DART SERVICE INSTRUCTION

TO AMEND INSTALLATION INSTRUCTIONS IIN-D412-702 REV. E AND
INSTRUCTIONS FOR CONTINUED AIRWORTHINESS ICA-D412-702 REV. 3

Update the D412-702-041A/045A/-041B/-045B kits for compatibility with the Dart D412-769-011 Aft Facing Seat Kit.

A	NEW ISSUE, NCR 09-068	CP	09.06.30
REV.	DESCRIPTION	BY	DATE
DESIGN		DART AEROSPACE LTD HAWKESBURY, ONTARIO, CANADA	
DRAWN			
CHECKED		DRAWING NO.	REV. A
MFG. APPR.	N/A	DSI 9469	SHEET 1 OF 5
APPROVED		TITLE	SCALE
DE APPR.		AFT-FACING SEAT UPDATE	NTS
DATE	09.06.30	COPYRIGHT © 2009 BY DART AEROSPACE LTD THIS DOCUMENT IS PRIVATE AND CONFIDENTIAL AND IS SUPPLIED ON THE EXPRESS CONDITION THAT IT IS NOT TO BE USED FOR ANY PURPOSE OR COPIED OR COMMUNICATED TO ANY OTHER PERSON WITHOUT WRITTEN PERMISSION FROM DART AEROSPACE LTD.

FIGURE 4.8. SHOULDER BELT INSTALLATION
FIGURE 25.12 D412-702-045A/-045B 4-MAN 3-POINT AFT FACING SHOULDER HARNESS KIT

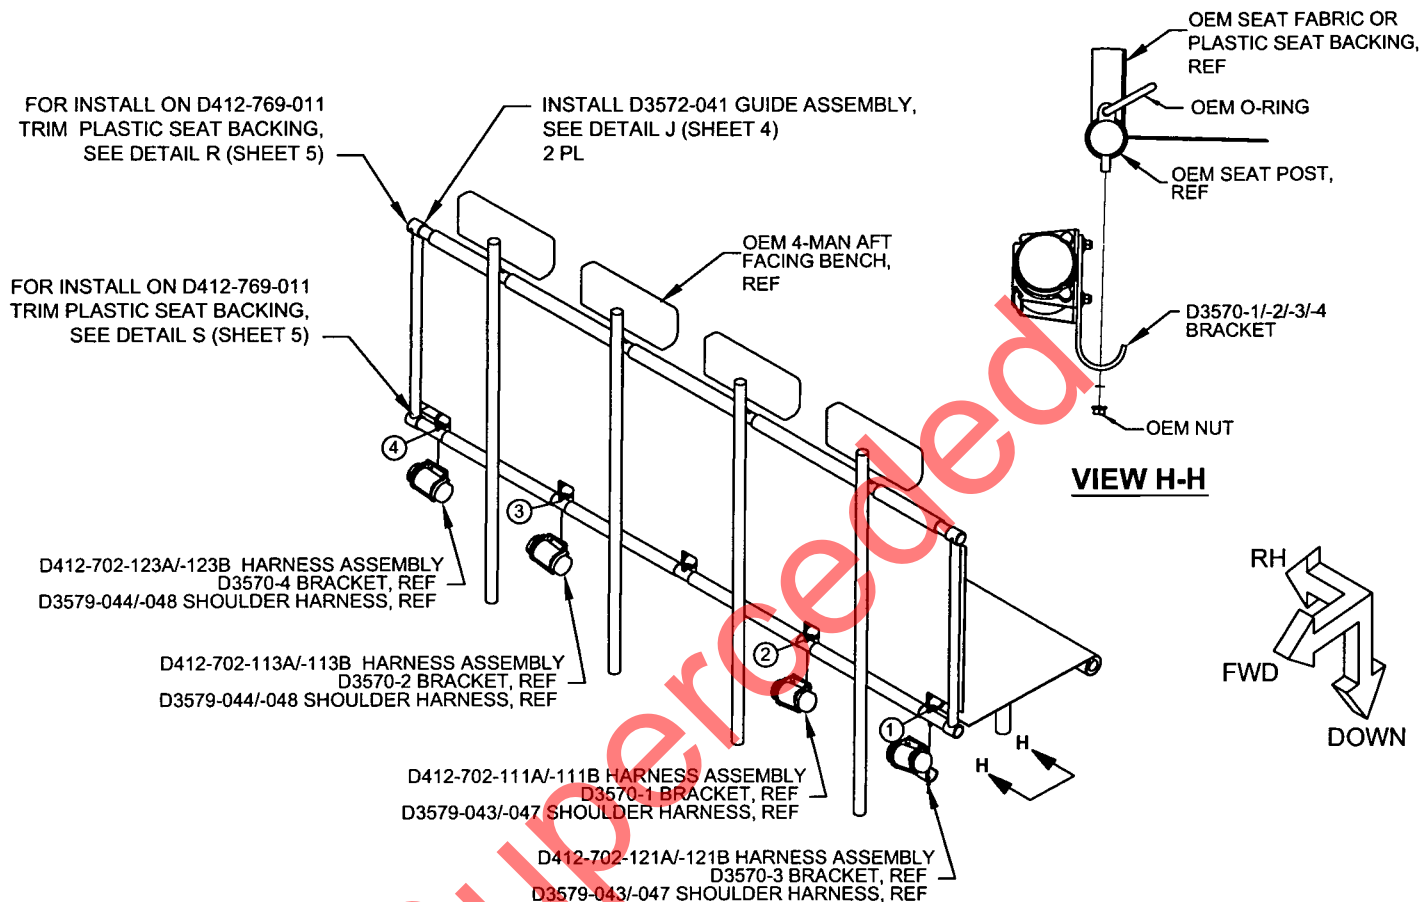
Figures 4.8 (pg. 25) of IIN-D412-702 Rev. E and 25.12 (pg. 69) of ICA-D412-702 Rev. 3 are updated as follows:

DETAIL J: D3572-041 INSTALLATION
(RH SHOWN, LH OPPOSITE)

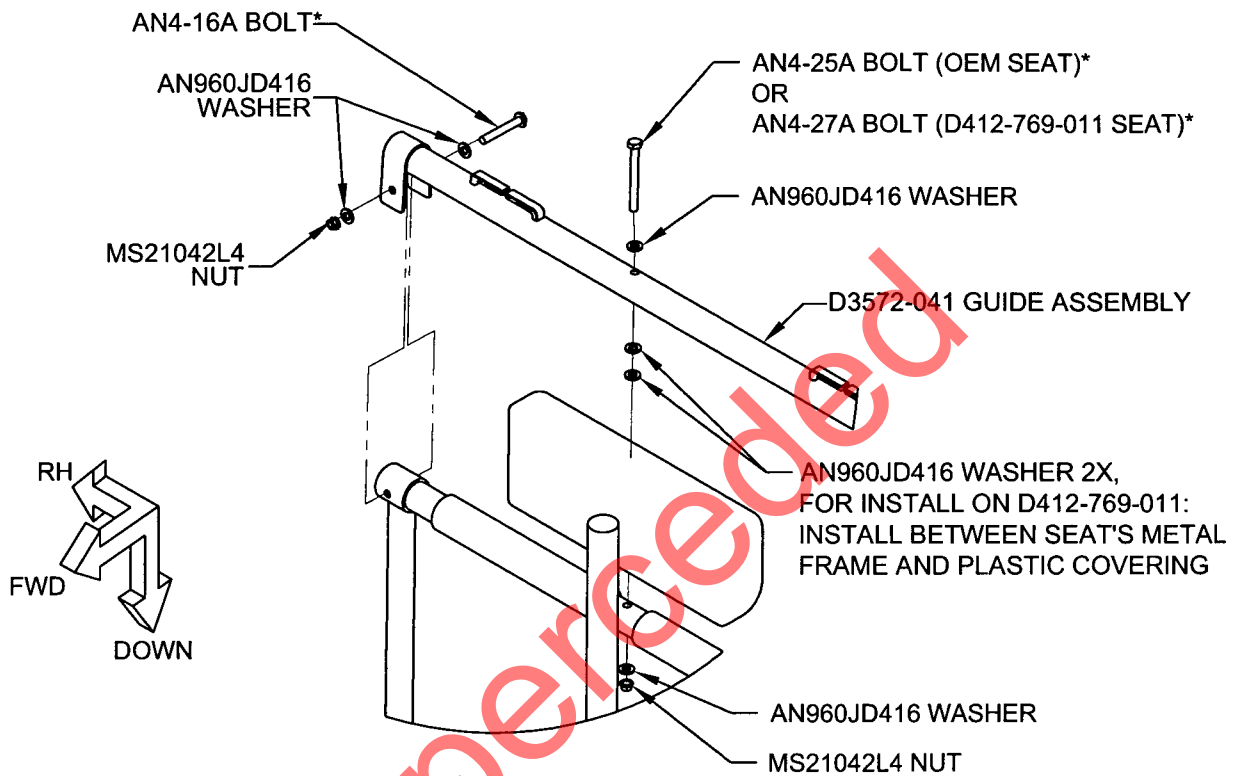
Quantity (1) each of D412-702-111A/-113A is replaced with D412-702-121A/-123A. Also Qty (4) x AN4-27A bolts are added to the kits for compatibility with the Dart seat. The parts list in section 25.28 (pg. 87) of ICA-D412-702 Rev. 3 and section 7.0 (pg. 38) of IIN-D412-702 Rev. E is amended as follows:
